**AT ISSUE**

The Draft Environmental Impact Report Section 4.3.2 illustrates and describes the Bourne South Quadrant's shared use facility terminating at **an at-grade crossing of the Canal Service Road (Sandwich Road)** controlled only by a flashing beacon. This poses both environmental and safety/usage issues detailed here.

Figure 2 - Location of proposed overpass versus existing path plan

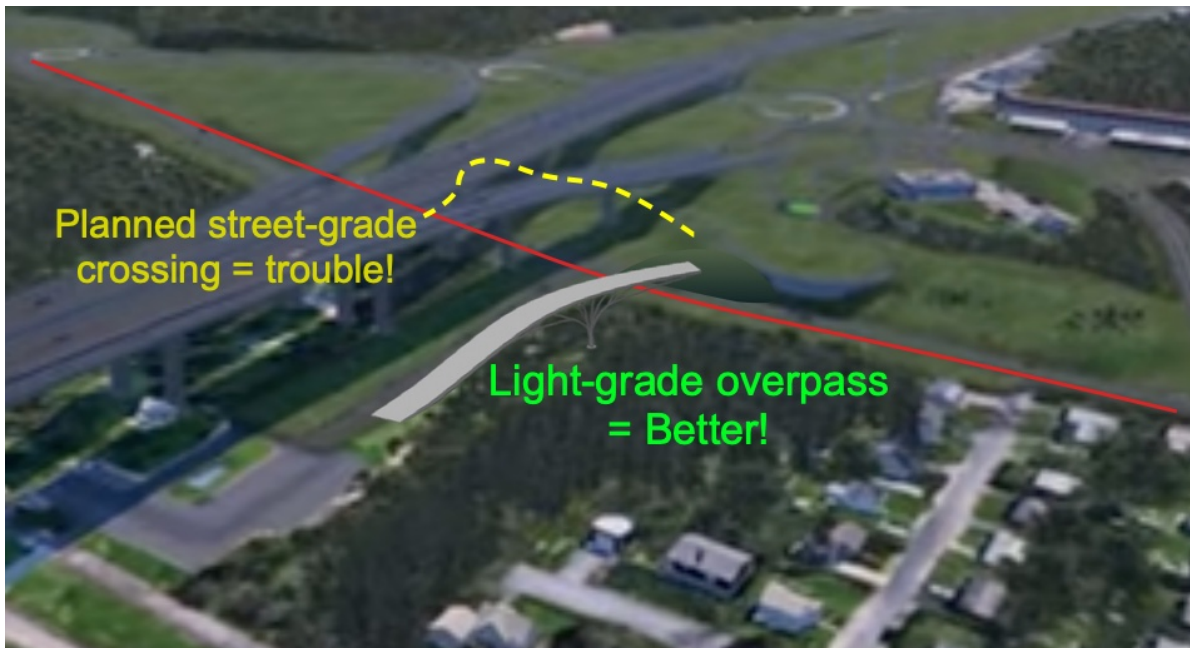
A light, ramped, grade-separated bike & walker overpass. It leverages existing site elevation, the already-planned retaining wall, and already-available land.

**The change leverages planned structures.** Rework planned berm for southerly overpass approach to the overpass, continuing on a northerly descent via light, non-vehicular structure.<sup>1</sup>

To support this, we respectfully request MassDOT **prepare a preliminary design and cost estimate (capital & operating) for this proposed lightweight overpass**. To assess its feasibility, we also request this be compared to the cost of the path with a HAWK signal, which is the only technically appropriate signal for the at-grade crossing at the anticipated volumes.

Figure 3 - Descent Ramp into existing public property

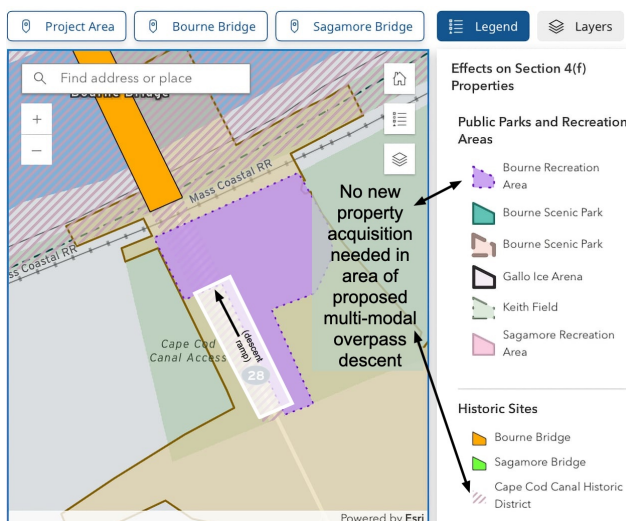
**No new property required.** Northern end can descend into the existing Bourne Recreation Area and Cape Cod Canal District property. No property taking is required.
